Appl. No. 10/761,728
Response to Office Action of August 14, 2006
Page 5 of 12

Amendments to the Drawings:

Remarks/Arguments:

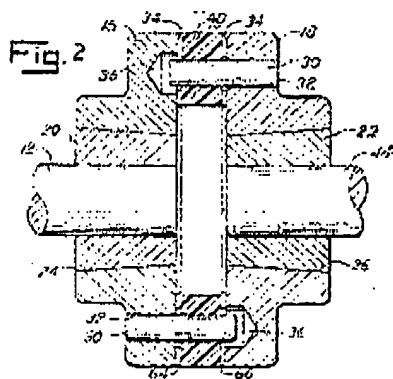
The Examiner has rejected claims 1-4, 8, 10 and 11 under 35 U.S.C. § 102(b) as being anticipated by U.S. Patent No. 3,798,924 to Downey. The Examiner states that Figs. 1-3 show a coupling comprising the claimed elements. Applicants disagree.

FIG. 5

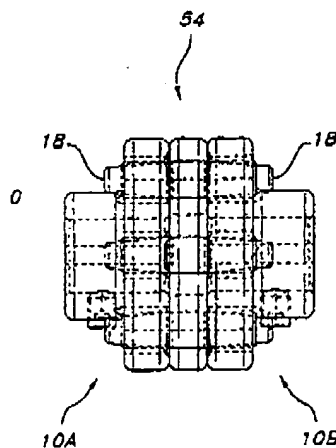
- Pin length

First, the Downey design does not provide its pins 30 having a "length sufficient to be received substantially completely by a means for receiving the pins." The Downey pins are barely received by the recesses 36, as shown below. By contrast, Applicant's pins are claimed and shown as substantially completely received by opposing openings. Figures from Downey and the instant application are reproduced below for comparison.

Even a slight disengagement of the Downey flanges would cause the system to fail, whereas if the hubs of the presently claimed invention were to disengage, the pins would remain in contact with the other hub, holding the system together.

FIG. 3

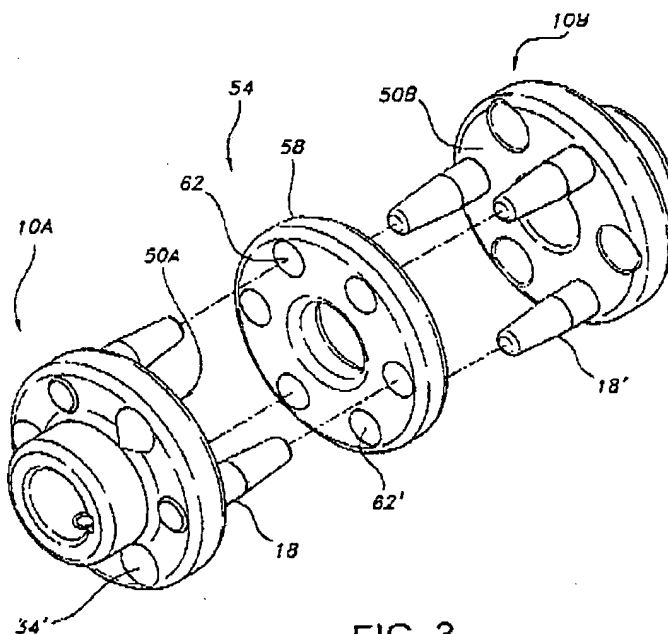
- Tapered free end

Additionally, in the interest of advancing the prosecution of this application, and in an effort to even further distinguish the structure of the claimed coupling from the art, Applicant has amended claim 1 to recite that its pins have a tapered free end. Support for this amendment appears in the specification at page 6, lines 3-4, and is shown in FIG. 1.

The tapered free ends are in contrast to the pins of Downey, which remain at a constant diameter throughout their entire lengths. The claimed tapers can help provide additional angular clearance, providing benefits that are not provided by the Downey design.
